**RESPONSE TO IDAHO DEPARTMENT OF WATER RESOURCES MEMORANDUM:  
"Review of Hydrologic Data Analyses Submitted by RMEA  
in Support of Application for Transfer 80496"**

Bryce A. Contor  
February 29, 2016

On February 3, 2016, Sean Vincent, P.G., Hydrology Section Manager of Idaho Department of Water Resources (IDWR) provided a memorandum (Memo) to James Cefalo, Water Resource Program Manager of IDWR. The Memo was a review of technical analyses submitted by Rocky Mountain Environmental Associates, Inc. (RMEA) in support of application for transfer number 80496 (Report). The subject of the Report was a pumping test on the Boyd Smith Point of Diversion, which is a vertical-turbine with a constant-speed electric motor, set in an 18 foot deep excavated sump, 650 feet from a slough used as part of the distribution network of the Liberty Park Canal system.

Figure 1. Raw Data - Full Time Series - Smith Pump Test

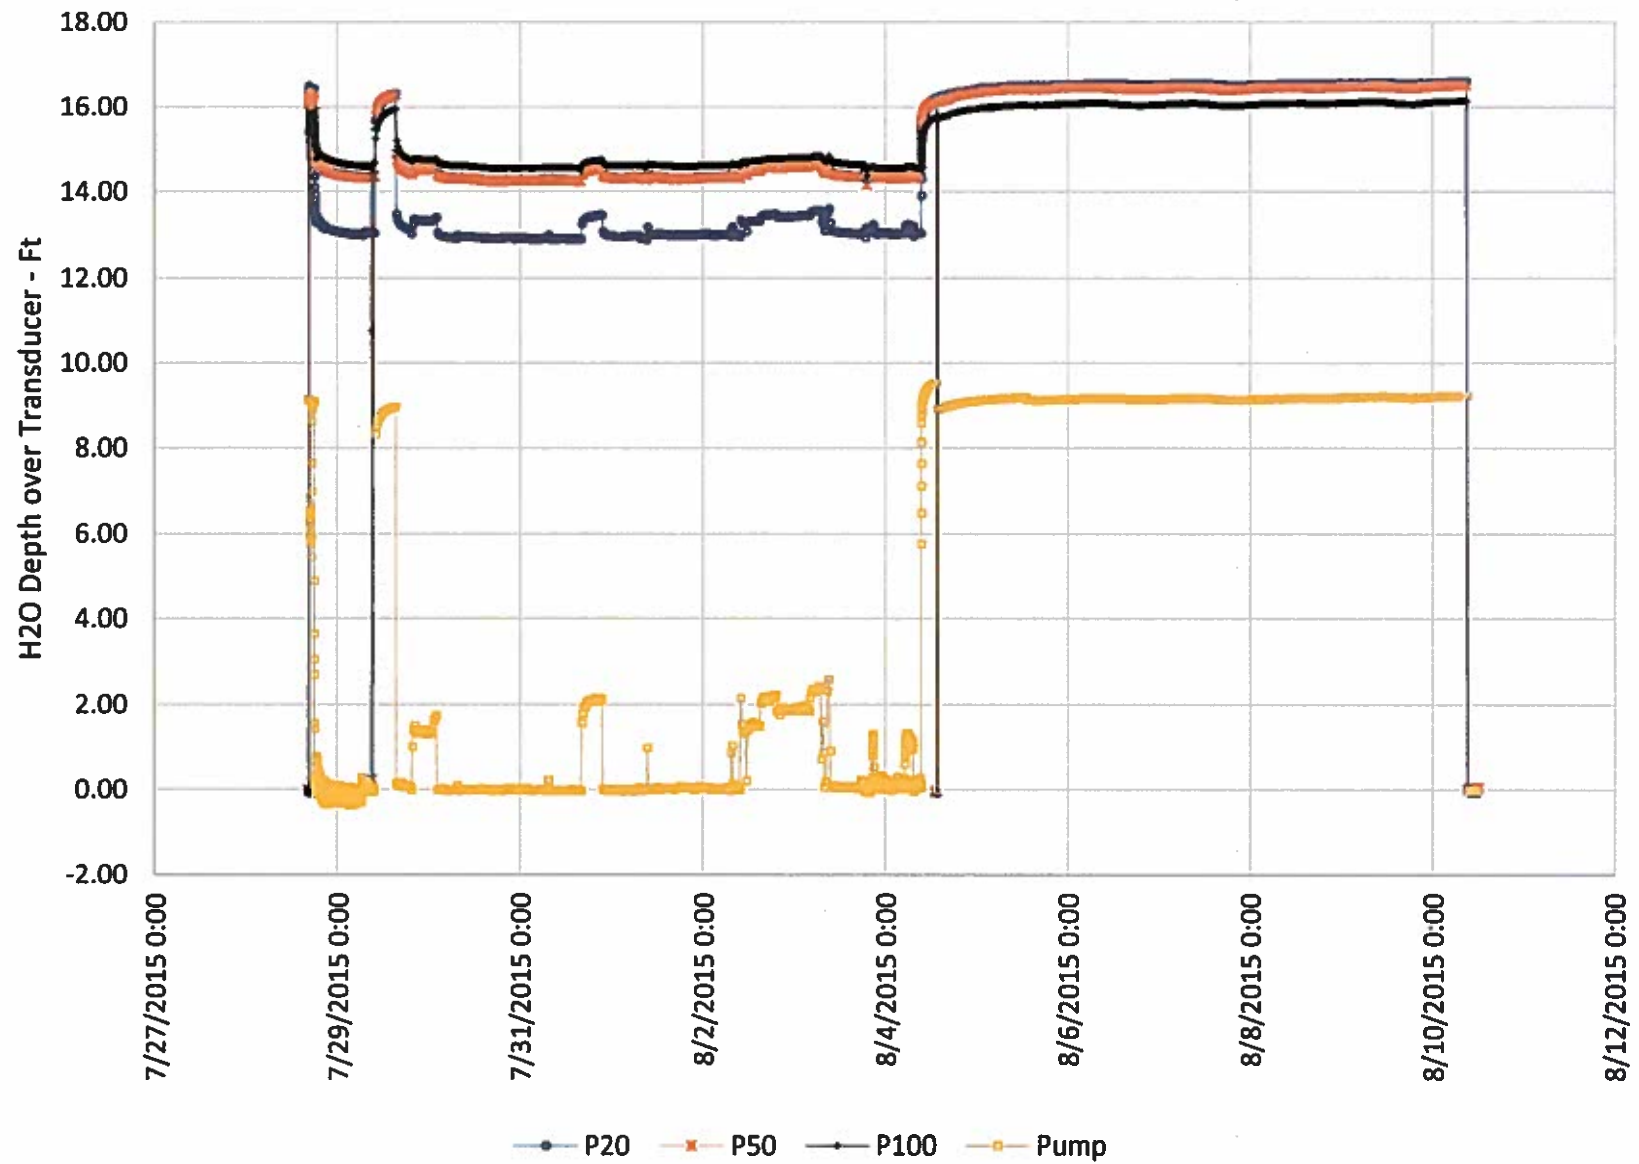
#### *1) No provisions were made for measuring the flow rate during the test...*

The test relied upon the operator's experience from measurement of pumping levels prior to the 2015 hiatus, that drawdown quickly stabilizes and remains essentially constant throughout the irrigation season. Data presented in Figure 1 show that the operator's expectation was met for the duration of the test.

Figure 10. P20 Early Pumping Graphical Analysis

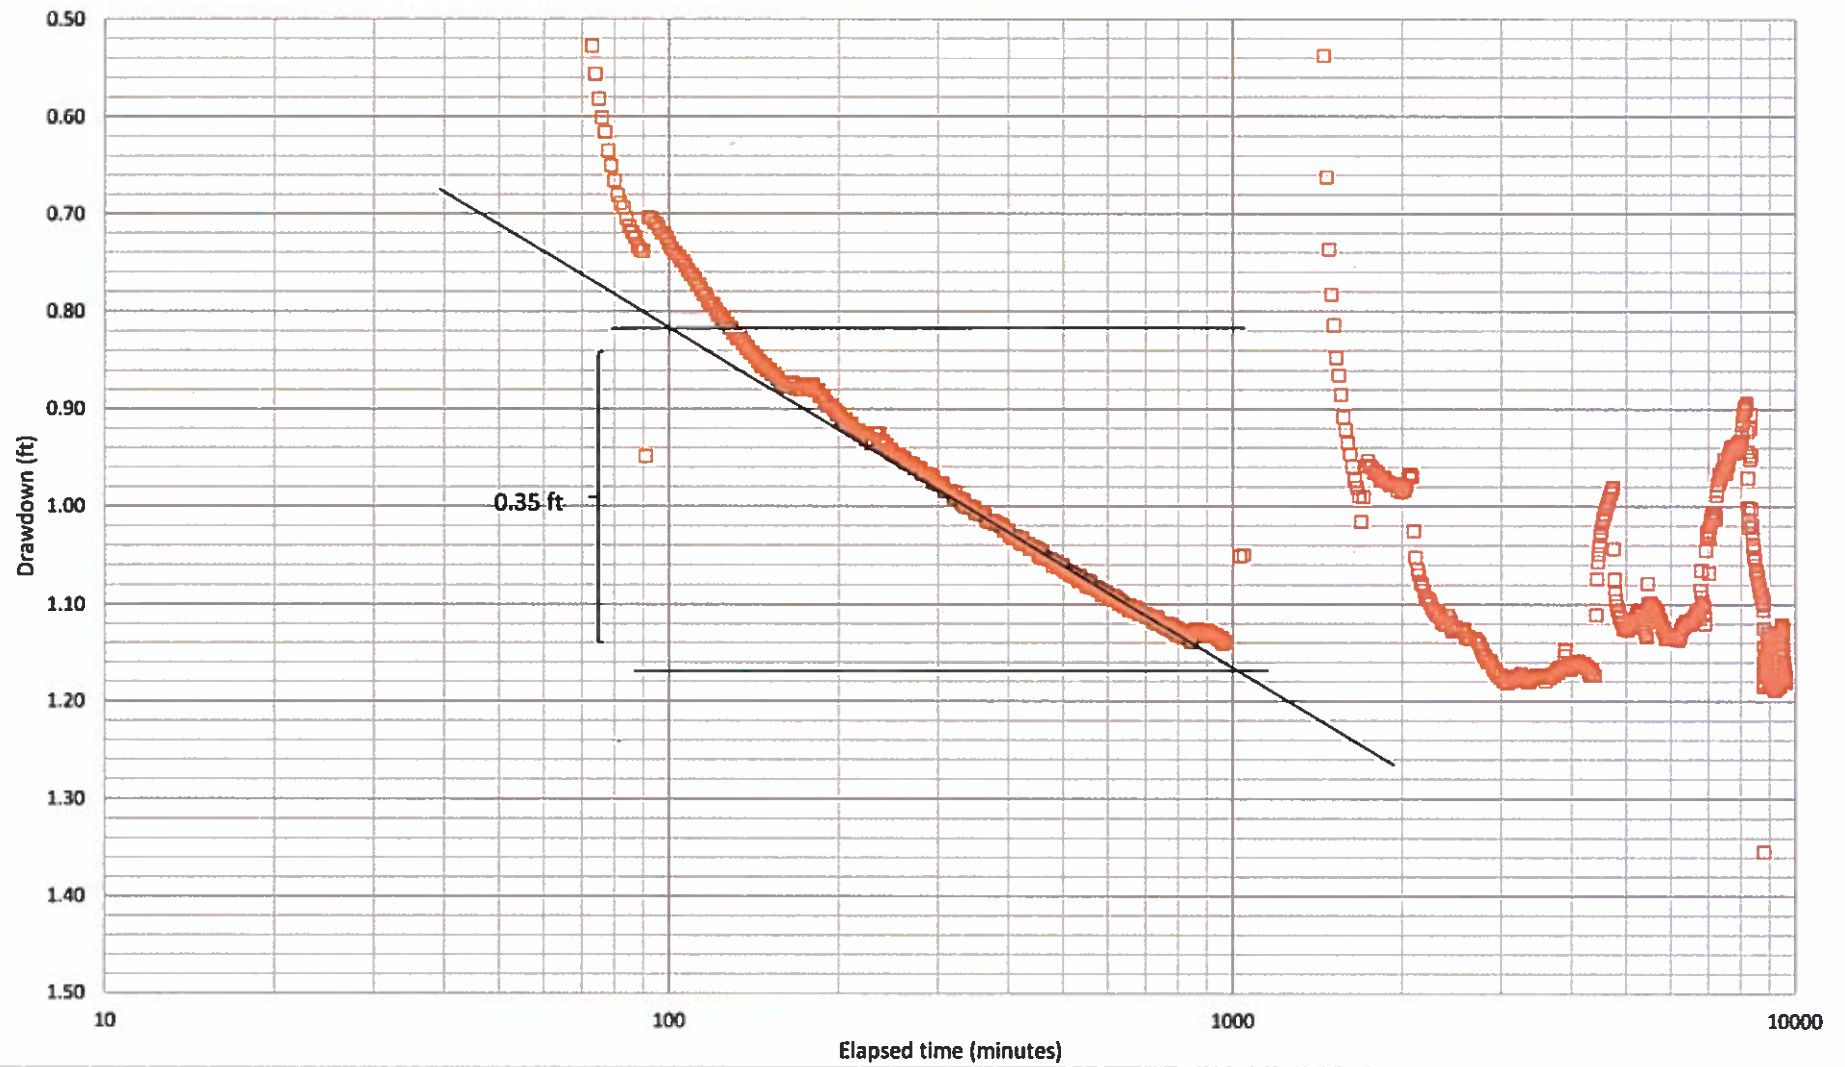
- *...individual data points are not discernable on the boundary analysis plots prepared by RMEA.*

Many of the revised figures include individual data points. For precision in analysis, some of the revised analyses still rely on plots prepared without the data points, because the time series traces are more distinct without the individual points. The P20 boundary analysis graphic was not reproduced with individual data points but Figure 10 shows the same data period plotted with the points.

Figure 13. Geographic Overview

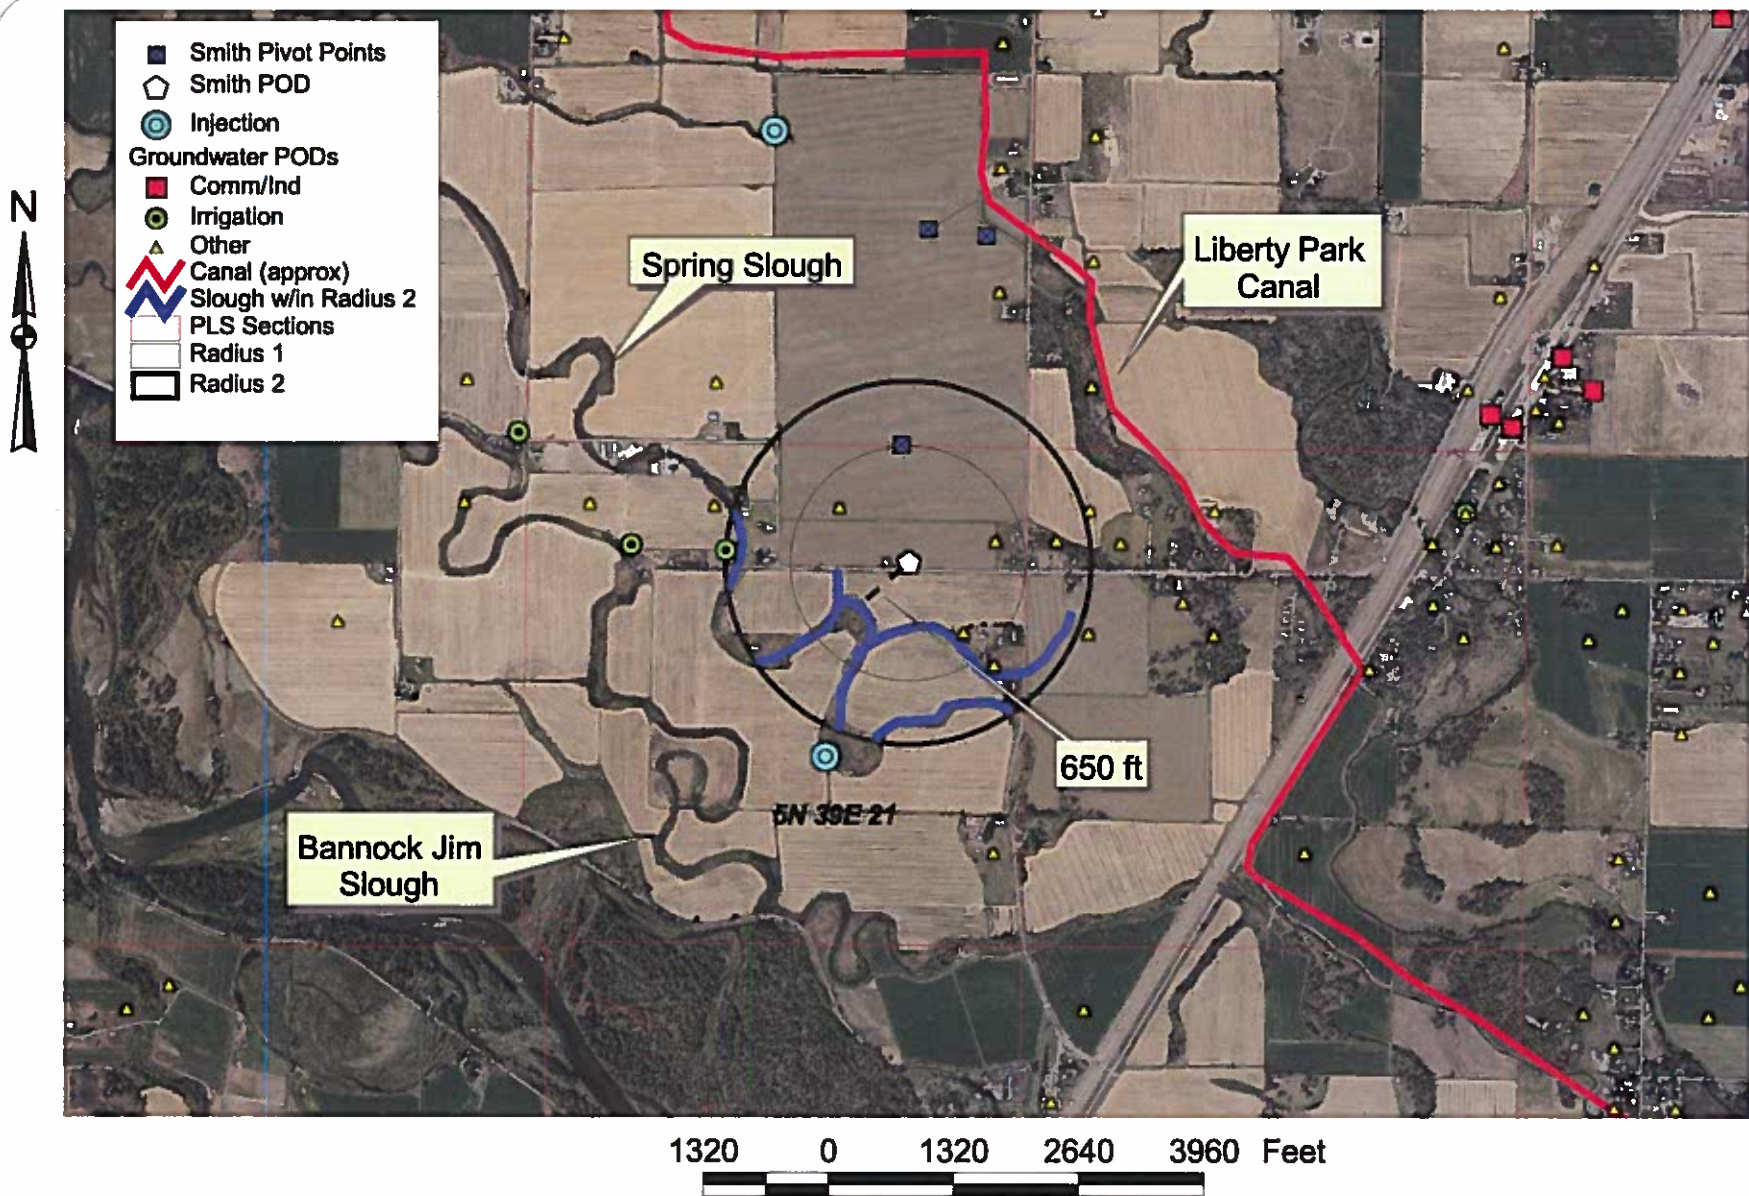
*None of the technical submittals... describe the nature and extent of the slough.... It does not appear... that the slough has an open water connection to the South Fork.... At least during the winter, the slough is not a substantial body of water in the vicinity of the POD....*

Figure 13 illustrates the geographic relationships between the Smith POD and other pertinent features. The visible surface expressions of the slough system arise in cultivated parcels south and east, and northwest, of the Smith POD. Two small branches of the slough combine just south of the Smith POD, into a larger slough that joins a northern branch approximately 7,500 feet in the north-northwest direction from the Smith POD. We agree that there appears to be no apparent open-water connection to the South Fork except for the mapped points where canal water is injected into the slough.

We agree with the IDWR characterization in the General Comments that the sloughs intercept groundwater, and point out that users have historically injected surface water into the slough system, to utilize it as a conveyance for Liberty Park Canal water. Two such injections are shown on Figure 13. During the period of proposed use, the slough

Figure 6. Semi-log plot of both drawdown and recovery data with lines showing the break in slope 700 minutes indicating the onset of near steady state drawdown.

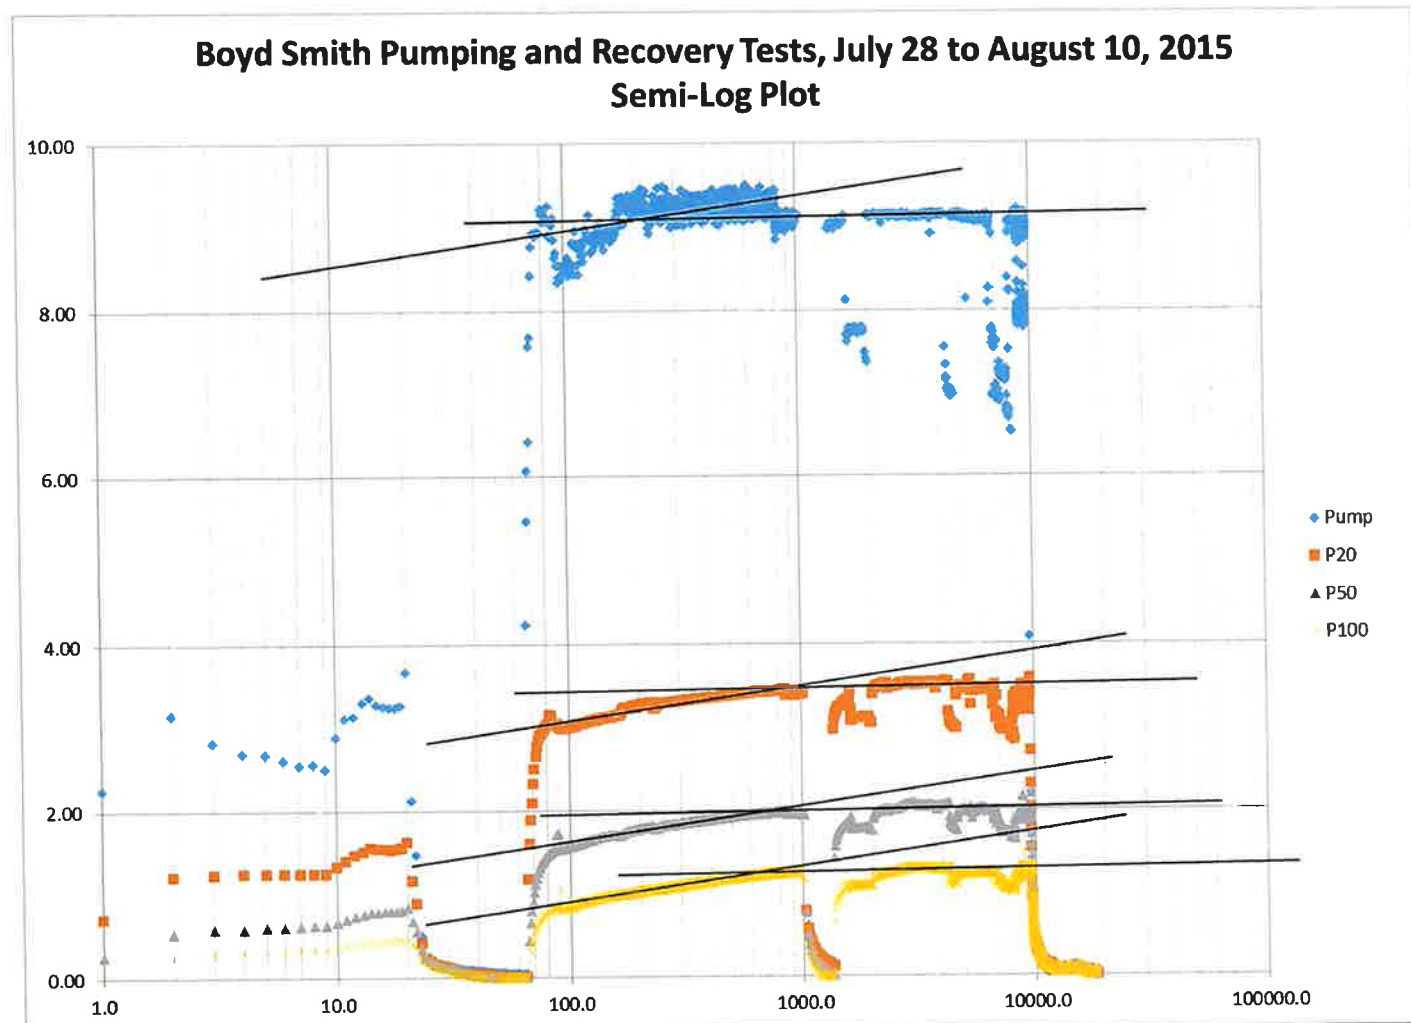
*...inspection of Figure 6 from [the Clearwater] report reveals that there most likely were at least two significant pump outages, the first beginning approximately 20 minutes after the test started and lasting for approximately 45 minutes... the test was not restarted after the first outage.... Fluctuations in the pumping rate reduce the quality of the water level versus time data.*

- *The boundary analysis plots for both P20 and P50 indicate that the drawdown at an elapsed time of one minute was 0.00 feet. In contrast, Figure 6 in the Clearwater Report indicates that there was measureable drawdown in both of those piezometers at one minute.*

There were two pump outages. As reported above, an attempt was made to obtain stepped-rate pumping data. This failed when approximately 20 minutes into the test, the system over-pressure switch stopped the pump. Following the rule of thumb of a recovery period exceeding the pumping period, the test was restarted approximately 45 minutes later, at a greater discharge rate allowing system pressures to be in the normal

This may be an artifact of the data adjustments rejected earlier in the Memo, or an artifact of which of the non-pumping measurements were selected as the zero point. The Clearwater analyses are withdrawn. As the revised analyses rely upon differences in drawdown, the selection of datum is arbitrary and irrelevant.

P20 Time/Drawdown

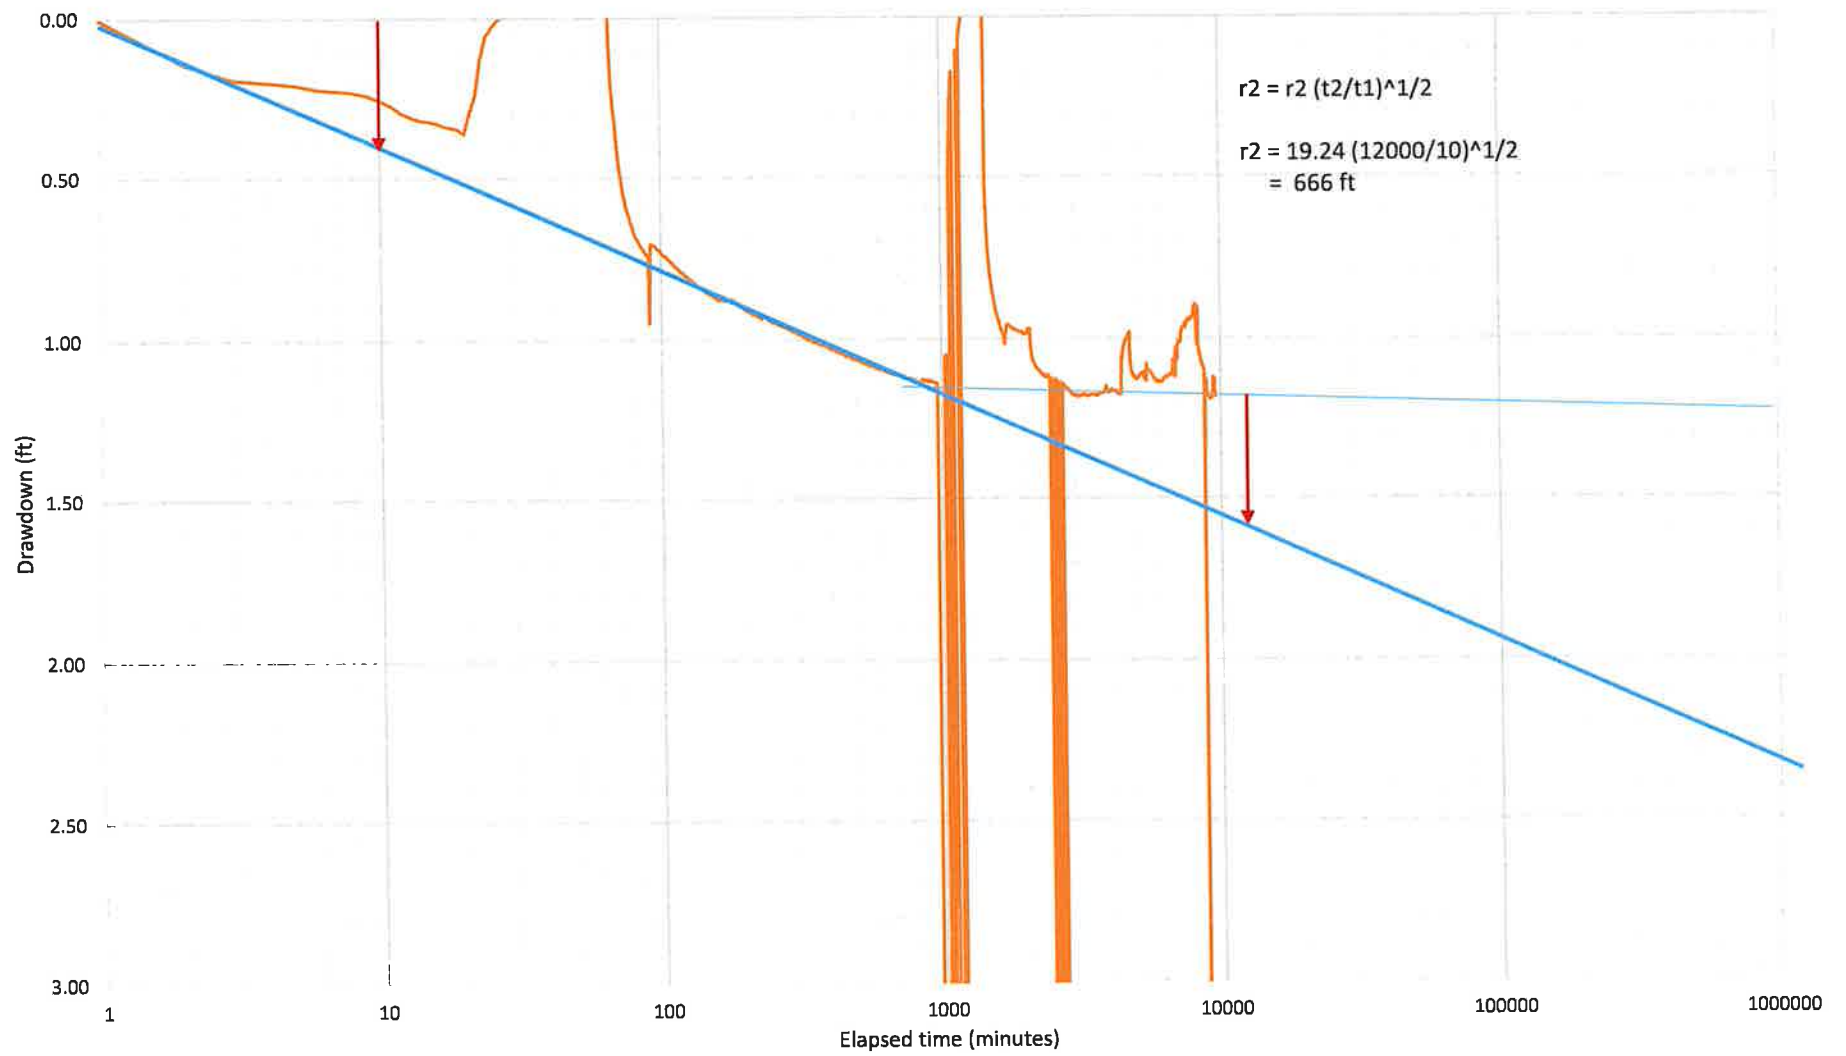
- 1) *The boundary analysis for P20 includes drawdown... from one to approximately 10,000 minutes.... The elapsed time on the P50 and P100 boundary analysis plots is only 800 minutes...*

- 2) *The boundary analysis plot for P20 shows the same response to the suspected pump outage between 20 minutes and 65 minutes... as observed in all four wells on Figure 6 of the Clearwater Report. Without explanation, however, complete water level recovery between 20 minutes and 65 minutes is not seen on the boundary analysis plots for P50 and P100.*

- 3) *The RMEA analysis interpreted a break/decrease in slope at approximately 900 minutes in the P20 plot... and between 10 and 20 minutes on both the P50 and P100 plots...*

As described above, due to the  $u$  criterion, only the P20 data are suitable for this analysis and the other analyses are withdrawn from consideration.

The times for the P50 and P100 plots were adjusted to reflect the restart of the test, while the P20 plot and the Clearwater plots were not. However, the P50 and P100 plots are withdrawn from analysis.

This is an artifact of violation of the  $u$  criterion. Upon further reflection, RMEA believes that the change in slope in the P20 plot is reflective of an encountered boundary, while the changes in slope in the other two plots represent the transition to a log-linear relationship when the  $u$  criterion was met. The P50 and P100 analyses are withdrawn.
